MoDOT's I-70 Evaluation

Public Works Recommendations
September 6, 2022

Figure 4: Recommended Yellow Alternative

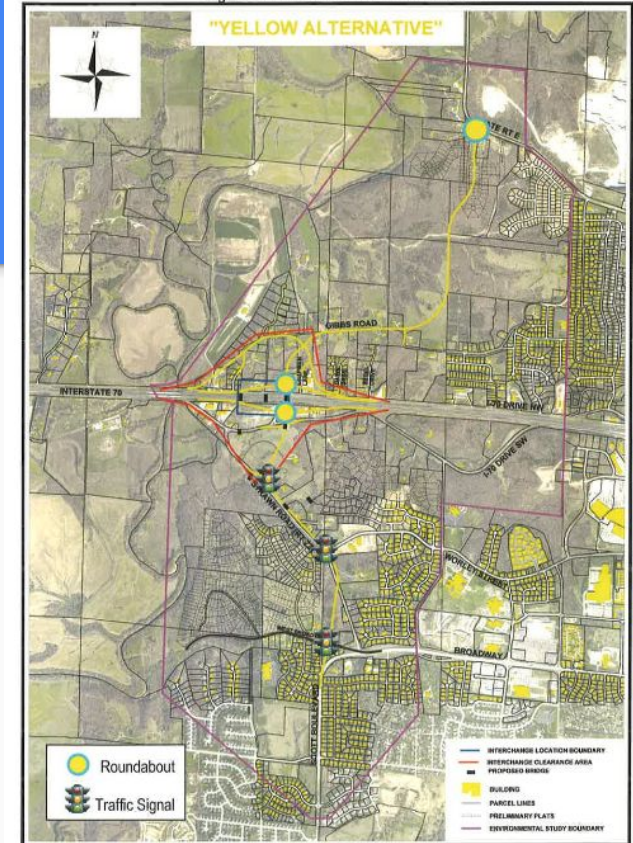
- Provides an outer road connection across Perche Creek and improves the existing outer road north of I-70
- 3 miles, 1 bridge
- Staff recommendation:
 - All proposals to date from MoDOT have appeared to specifically avoid any possibility of construction of any aspect of the Scott Boulevard interchange. The City has an FHWA approved Access Justification Report (AJR) for the interchange. Providing another connection across Perche Creek is critical for long term emergency response for both the County and City. During periods of significant delay along I-70 due to construction or significant incidents, travelers often utilize UU (MoDOT) to Gillespie Bridge Road (County and City) to Scott Boulevard (City) to access other routes around the incident backup. While relatively rare, the additional vehicle loads on City streets accelerates deterioration as well as impacting travel during those times. Another connection across Perche at this location should be a critical component of an improvement project in order for travelers on the Federal system to be able to stay on the federal system during periodic construction or incidents. The improvement should align with the findings of the AJR (see next slide, recommended AJR alternative). Another crossing of Perche is in MoDOT's Tier 3 Unfunded Needs list (page 35):

ALTERNATIVE 3
163-763
MINOR CD SYSTEM

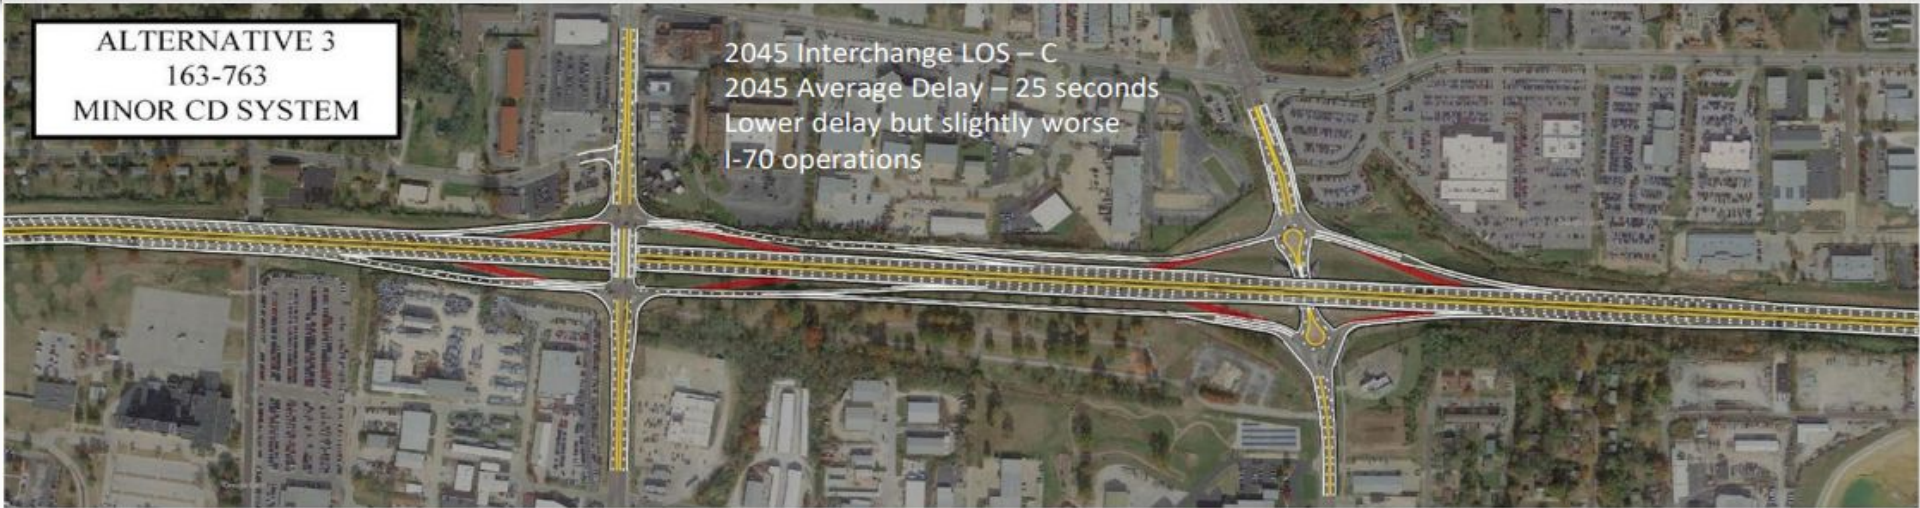
- Provides collector/distributor roads between Providence and Rangeline. The westbound off ramps and eastbound on ramps are combined, therefore Rangeline traffic to/from the west must go through the signals at Providence.
- The Loop CID's recommendation: "We do not support the addition of the north and south outer roads between Providence and Rangeline, nor the proposal to limit immediate access from I-70 to Rangeline (or vice versa). We don't believe the drivers should be redirected to the signal at Providence."
- Staff recommendation: What is proposed is consistent with access management best practices used throughout the federal highway system provided it also addresses non-motorized transportation needs.

ALTERNATIVE 2
163-763
MAJOR CD SYSTEM

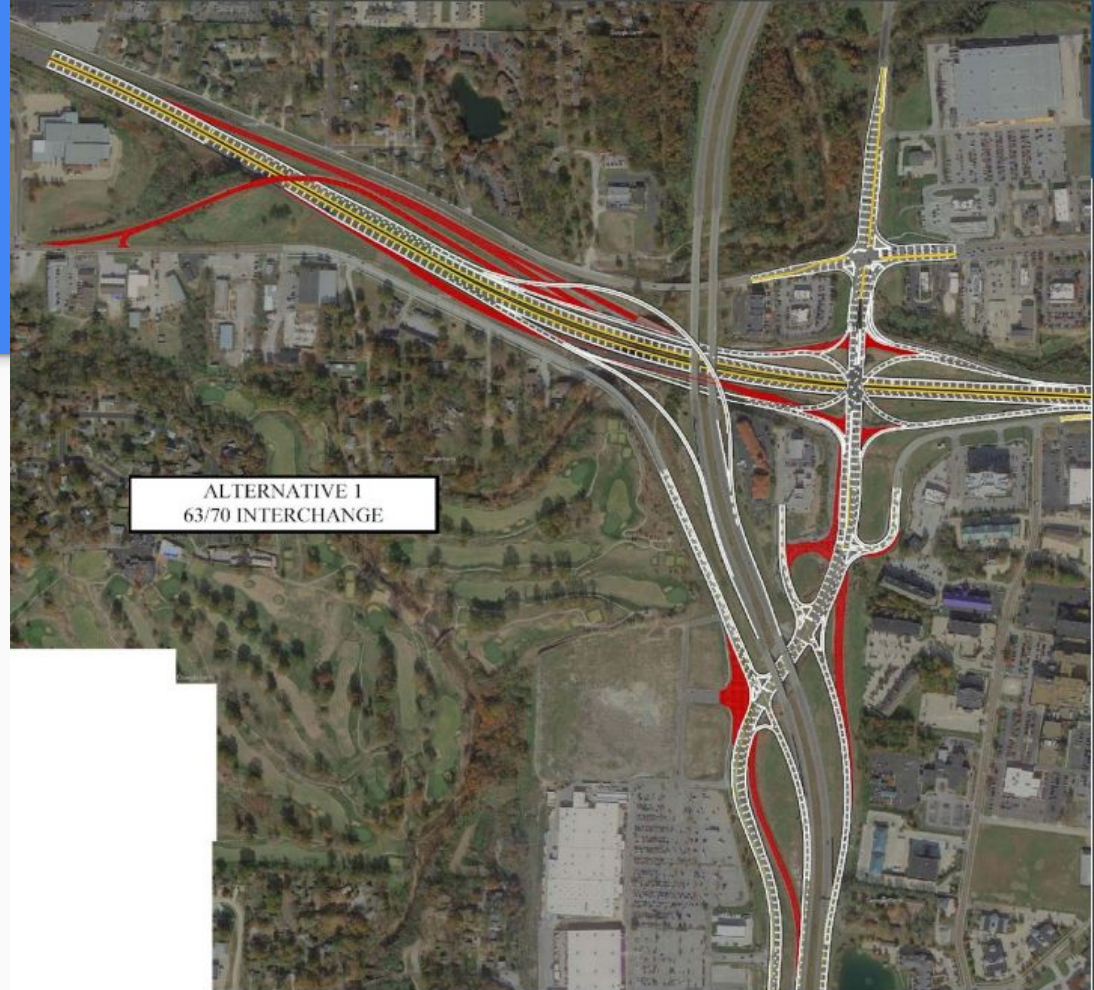
- Provides collector/distributor roads between Providence, Rangeline, and a new interchange at Parker. Grade separations are provided so that any combined ramps are not required to go through additional signals.

- The Loop CID's recommendation: "We would support the addition of the Parker extension and off/on ramp for I-70 (via the outer road), provided it is decoupled from the dual outer road proposals between Providence and Rangeline."

- Staff recommendations:
 - City leadership should carefully consider a firm position regarding the interchange at Parker. This interchange would be of potential significant long term benefit to the City as a whole. MoDOT is unlikely to desire promoting the construction of this interchange and is actually more likely to desire not to construct it due to costs. Without clear, strong support of the interchange from the City, it is highly likely the interchange will not be pursued.

- All proposed iterations at the Rangeline location do not adequately address poor non-motorized travel accommodations along Rangeline under I-70. Previous vehicular improvements made at the location decreased non-motorized accessibility. While the use of roundabouts was a better choice than signalization, specific re-evaluation of conflict points for entries to the roundabouts is needed. Entry and exit angles, especially for both bypass lanes south of I-70 are too oblique and appear to contribute to crashes at the location, especially for the eastbound ramp. Sight distance for the eastbound movement to the north is limited. Significant weight should be given as to how to improve the level of service of non-motorized travel to better than existing and at least as good as prior to the roundabout improvements.

I-70/US 63 Connector (Alternative 2)

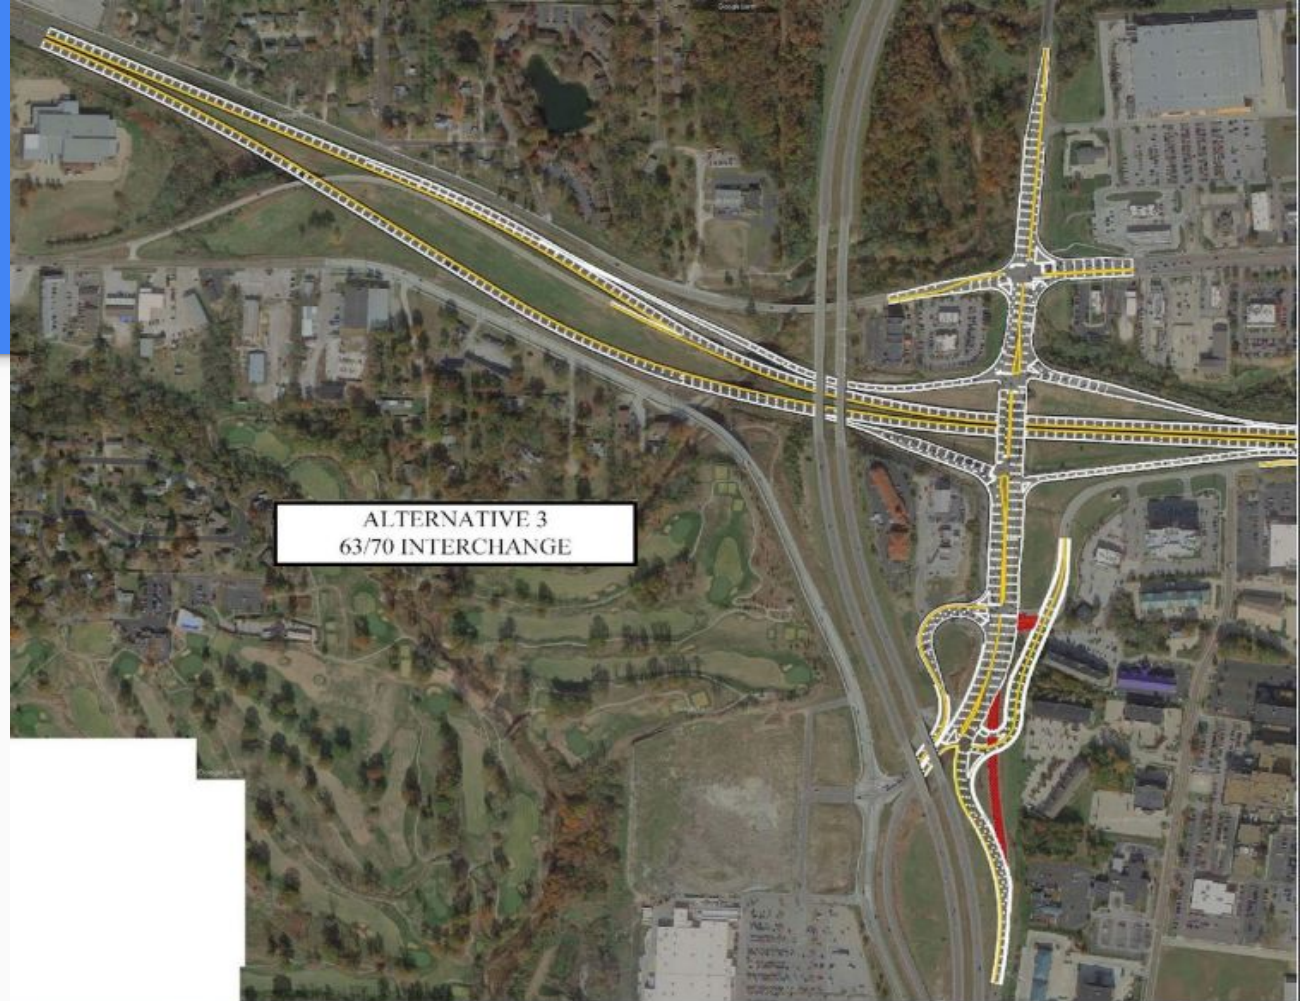
- The Loop CID's recommendation: "We will continue to review the proposals for the I-70/63 connector but again, we support long-term solutions here as well as strengthening other existing alternatives in order to relieve traffic along I-70. We would support an option that required removal of the left off ramp from I-70, especially if the Parker addition was an option.

- Staff recommendations:
 - The most recent iteration of preferred alternatives removes a signal from the City's maintenance, but creates several potential issues for City properties and roadways. It eliminates an organized entry/exit (the signal) to the Broadway Marketplace location without sufficiently addressing the volumes entering and exiting the retail location. There is no shown improvement as part of the project either north or south of the location that provides for protected left turns into or out of the shopping center. This must be addressed as part of the project.

Exhibit S-1 Preferred Alternative

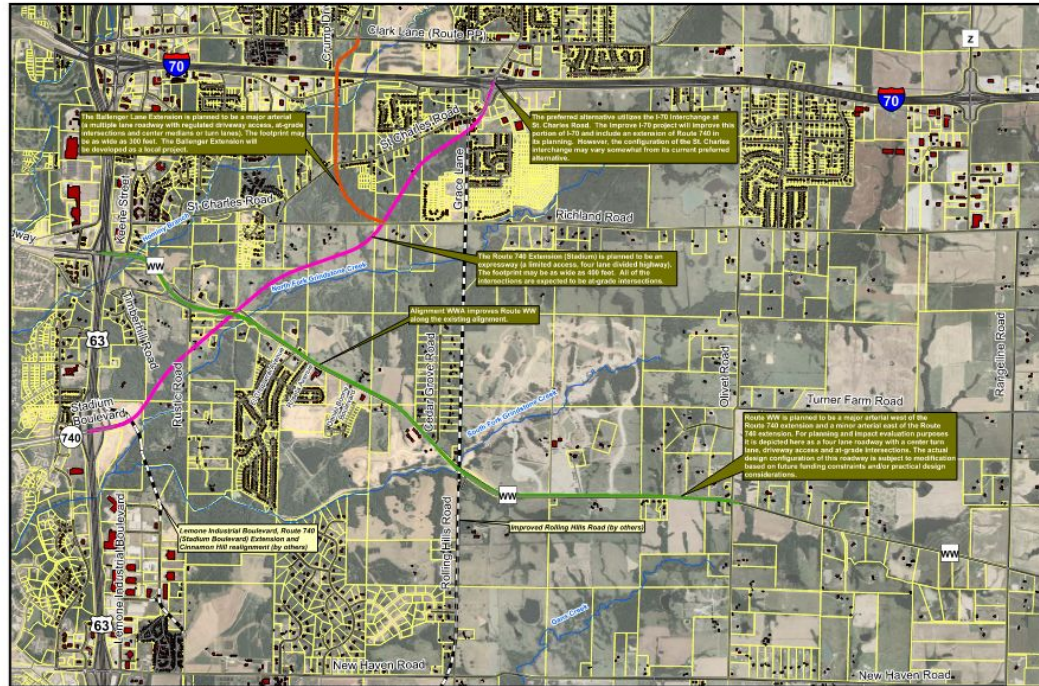
- The East Columbia Environmental Impact Statement (EIS), completed in 2009, should be updated. This will help determine long term transportation improvement needs east of US 63 including major interchange and overpass improvements for I-70. Funding for a portion of Stadium (US 63 to Route WW) is listed in Tier 3 for MoDOT's Unfunded Needs list (page 35):
<https://www.modot.org/sites/default/files/documents/2022-01%20FINAL%20High-Priority%20Unfunded%20Needs.pdf>.

St. Charles/Lake of the Woods

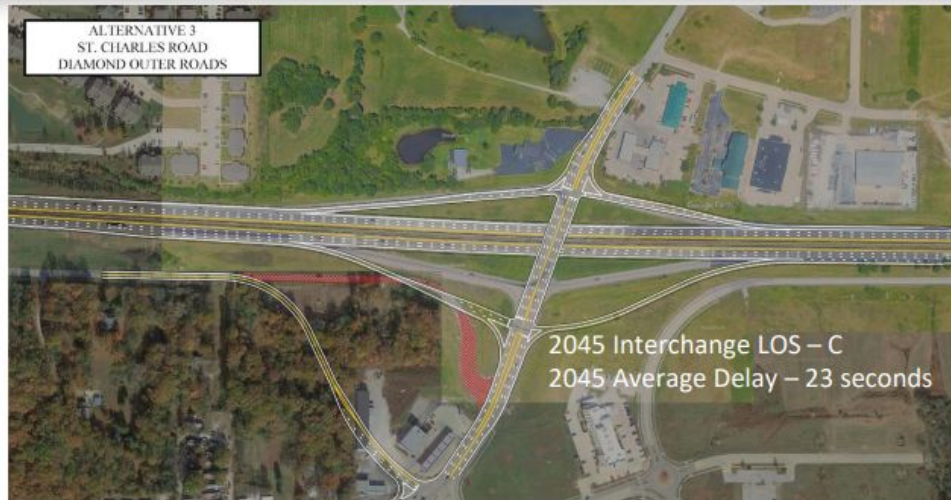
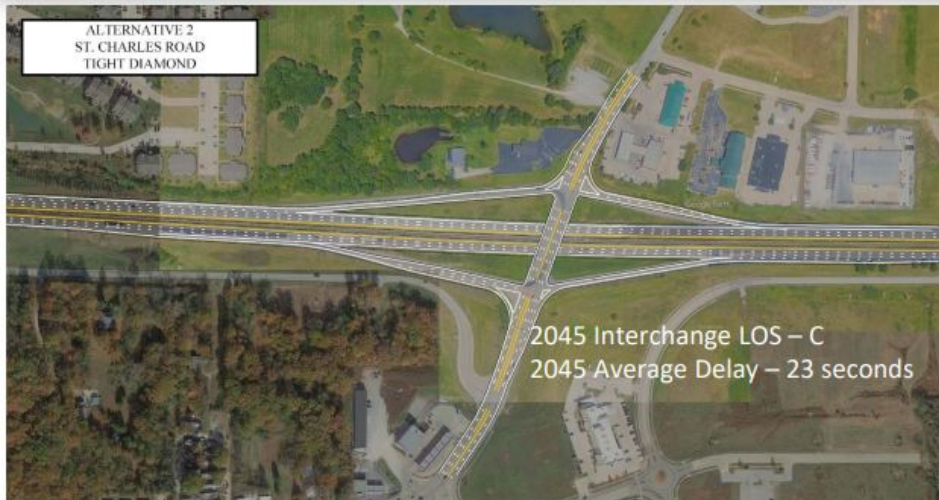
- The Loop CID's recommendation: "St. Charles/Lake of the Woods interchange should be improved and coupled with a plan to complete the extension of Stadium Boulevard from its existing terminus at Highway 63 to the improved St. Charles/Lake of the Woods interchange. This alternative provides the most effective way to relieve traffic at the I-70/Highway 63 intersection."

- Alternative 2 replaces and widens the overpass for additional lanes.
 - Staff recommendation: Staff recommends that the East Columbia EIS be updated. This will provide the best information about how Stadium and other roadways and interchanges should be improved.

- Alternative 3 replaces and widens the overpass for additional lanes and relocates the eastbound ramps and south outer road.
 - Staff recommendation: Staff recommends that the East Columbia EIS be updated. This will provide the best information about how Stadium and other roadways and interchanges should be improved.
